1121 SEYMOUR STREET (COMPLETE APPLICATION)  
DE416617 - ZONE DD

**EXECUTIVE SUMMARY**

**DEVELOPMENT PERMIT STAFF COMMITTEE RECOMMENDATION: APPROVE**

**A.024**

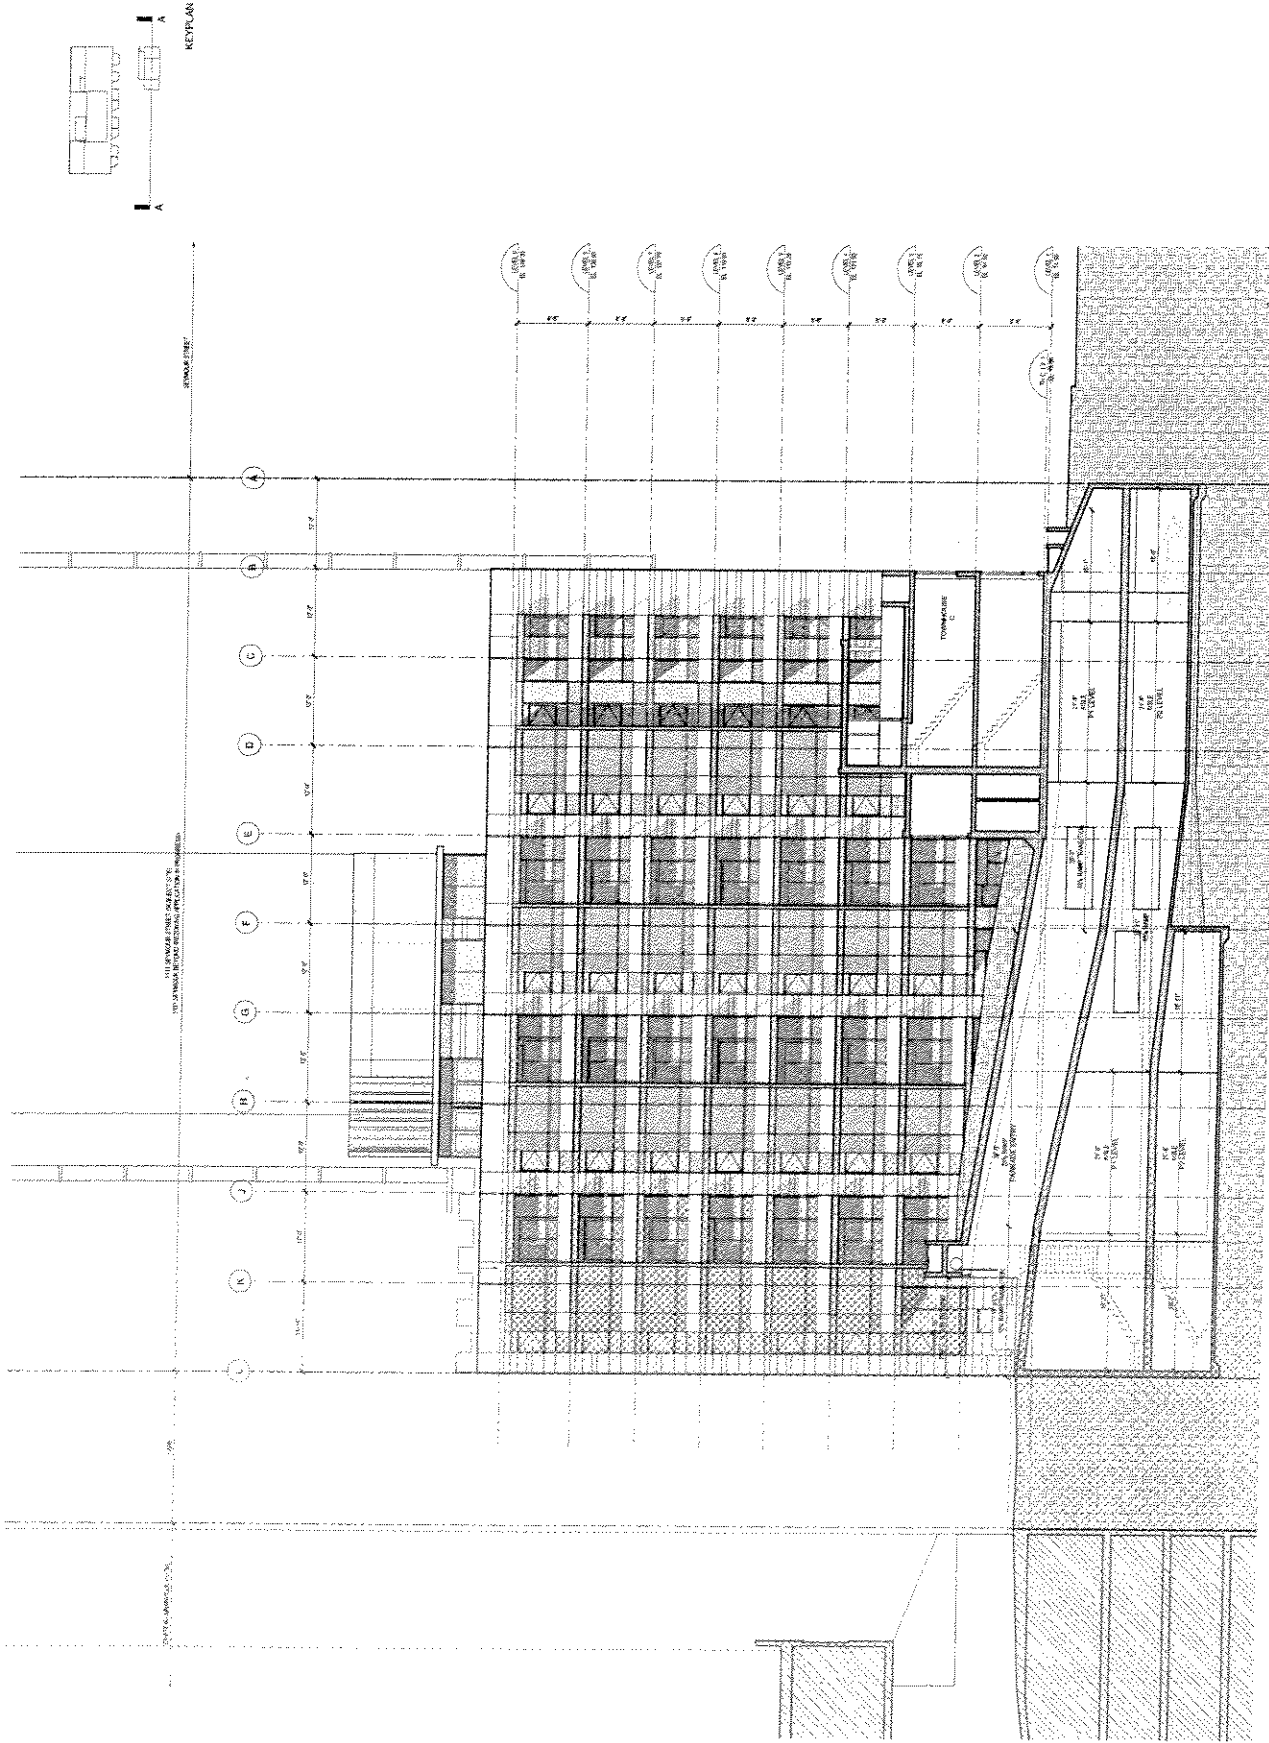
**Note to Applicant:** Sheet No. A.024 shows a minimum vertical clearance of 4.91' (1.5m), and a sign should be installed indicating "CAUTION - LOW CLEARANCE" in minimum 10 cm (4 in.) high black letters on a yellow background.
